22 February 2010

**RE: GRAYTHWAITE STAGE 1 PROJECT APPLICATION
APPLICATION NO. MP10-0150**

Figure 1: North Sydney Council's proposed height controls for the Shore School/Graythwaite site

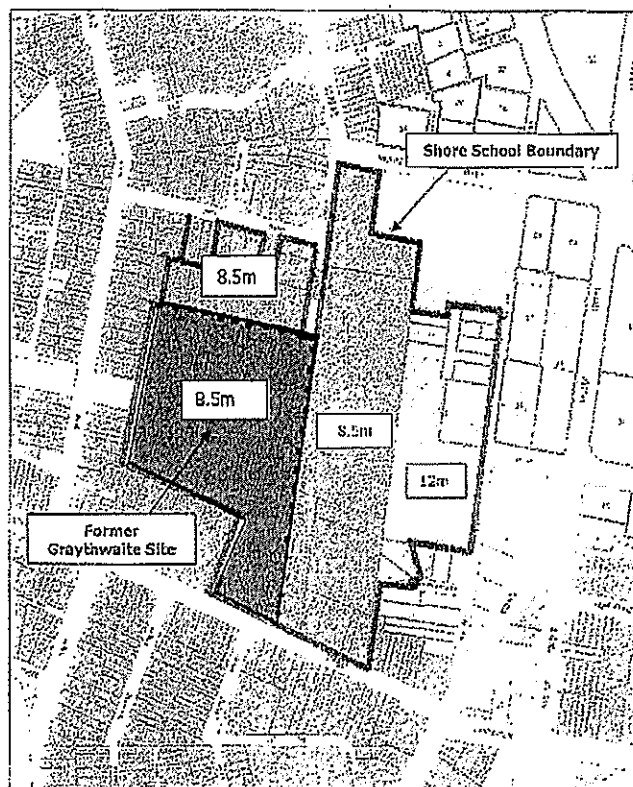
The letter states “*The Department supports Council’s request that 12m and 8.5m height limits be conditioned for Shore School site, and that an 8.5m height limit be conditioned for the former Graythwaite site in accordance with fig.1 below*” (emphasis added). See Annexure A.

I cannot see how the Minister could possibly approve a building, shown in the Concept Plan with a height of approximately 14m, and which is so at variance with the Department’s own recommended height limit?

The Department supports Council's request that 12m and 8.5m height limits be conditioned for the Shore School site, and that an 8.5m height limit be conditioned for the former Graythwaite site in accordance with Figure 1 below.

- Amend the Height of Buildings Map - Sheet HOB_005 to show maximum building heights of 12m and 8.5m for the Shore School/Graythwaite site
